**Future Australian Electricity Generation Costs
- A Review of CSIRO's GenCost 2021-22 Report**

David Carland

Australian Resources Development Pty Ltd

Figure 11. Ratio of battery and VRE generation capacity (GW) required to achieve energy balancing for modelled shares of energy (GWh) delivered by VRE

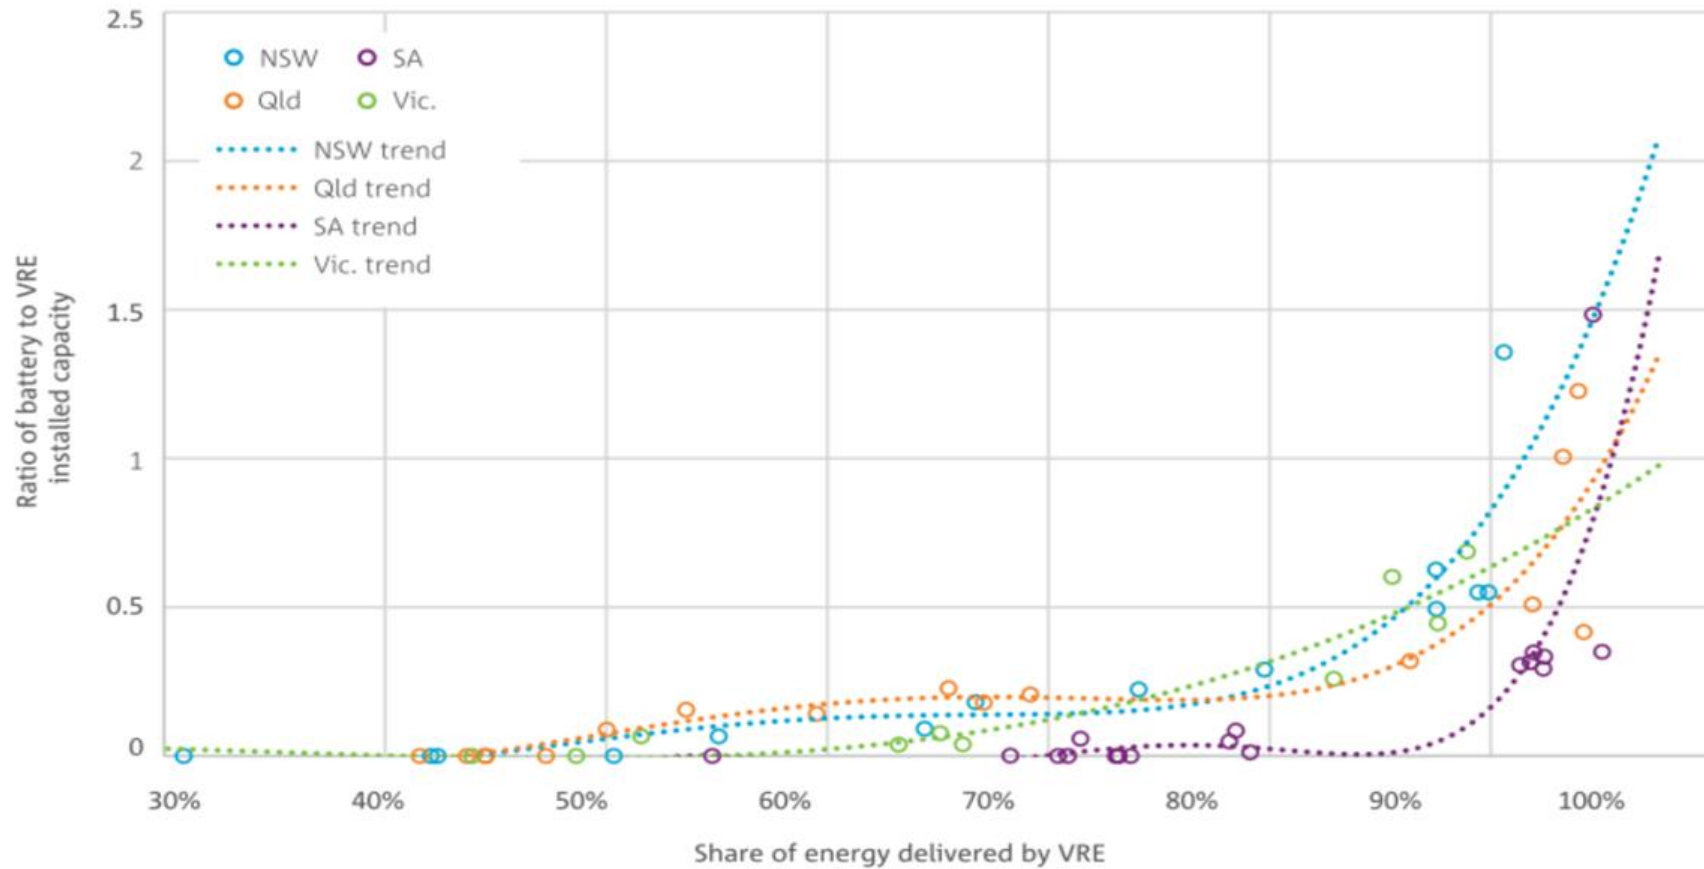
Appendix 3 reproduces Figure 11 of the CSIRO 2017 Roadmap which depicts the relationship between the VRE Share and the Firming Ratio in the NEM regions which increases exponentially as the VRE Share increases. Half-hourly modelling was used to derive these estimates in order to capture the rapid swings in VRE generation due to weather variability.
